**PROJECT NO. 53401**

**ELECTRIC WEATHER  
PREPAREDNESS STANDARDS –  
PHASE II**

**VISTRA CORP.’S COMMENTS ON PROPOSED RULE REGARDING PHASE II  
WEATHER PREPAREDNESS STANDARDS**

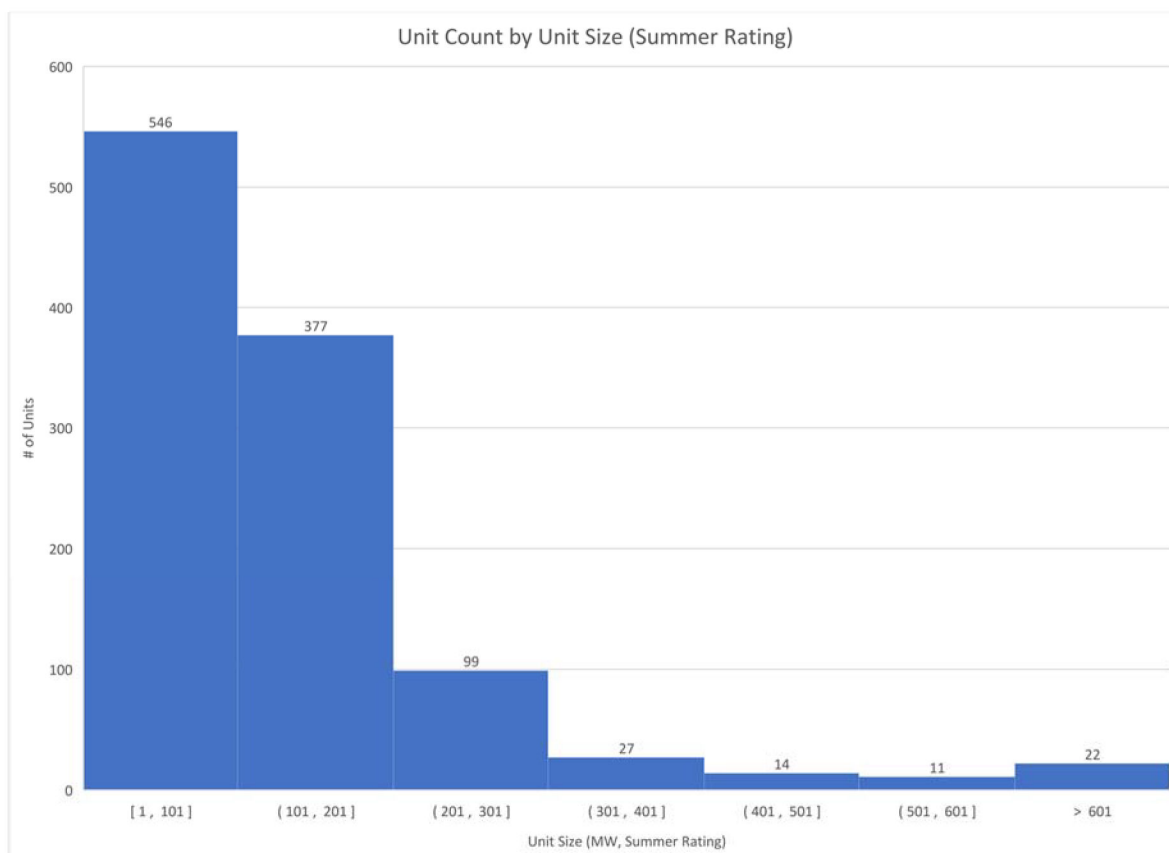
The Proposed Rule would define the term based on the loss of 7,500 megawatt-hours (MWh) of generation capability “occurring as a result of a weather emergency.” This proposed MWh-based measure would result in a regulatory structure biased against large dispatchable generators, because a forced outage or derate for a sizeable generation resource could trigger the “major” threshold within a matter of hours, but it may be several days or even weeks of a forced outage before a smaller resource would trigger the same threshold and its attendant independent review process, notwithstanding that forced outages of multiple small resources would have the same reliability impact as a forced outage of a single large resource. Thus, as proposed, the definition would create an arbitrary distinction in its application to different resources that would

To put the proposal in perspective, setting aside for simplicity any considerations about whether or when a unit would otherwise be committed, a 50 MW unit would have to experience a forced outage of 100 percent of its capacity for nearly a full week<sup>11</sup> due to a weather emergency to trigger the Proposed Rule's standard, while a 1,200 MW unit would trigger the standard based on a 50 percent derate for only 12.5 hours.<sup>12</sup> For context, consider that the vast majority of generating units in ERCOT are 300 MW or less, and the average unit size is about 130 MW (closer to 170 MW if counting thermal units only).<sup>13</sup>

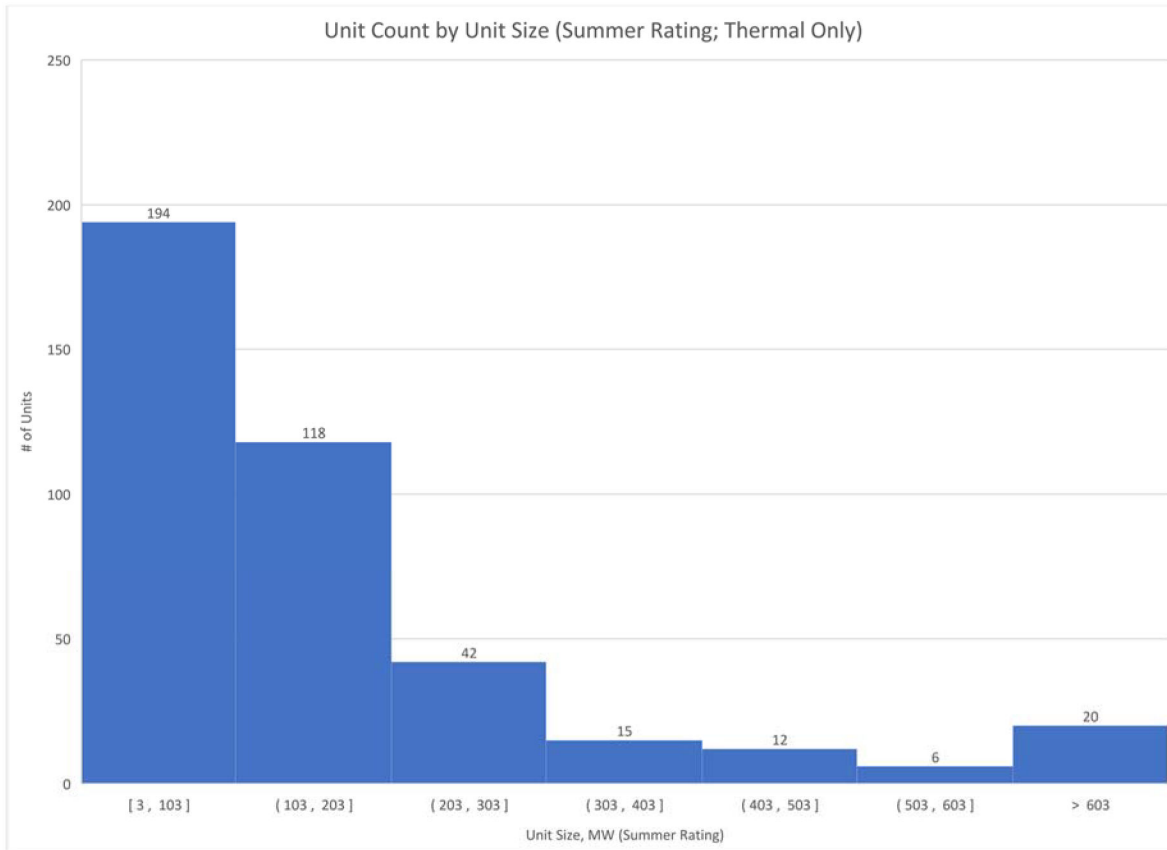
The weather-related events that seemingly have had the greatest impact on consumers have been ones where several resources, of varying sizes, lost a significant portion of their capacity for several hours to several days. As indicated above, those are the types of events that prompted the Legislature to adopt a requirement in Senate Bill 3 for the Commission to require an independent review of weather preparedness plans in the event of “major” (or repeated) weather-related forced interruptions of service. Thus, the standard should be one that would apply to any resource experiencing a relatively significant loss of its individual capacity for a significant duration of time, regardless of the size of the individual generating unit.
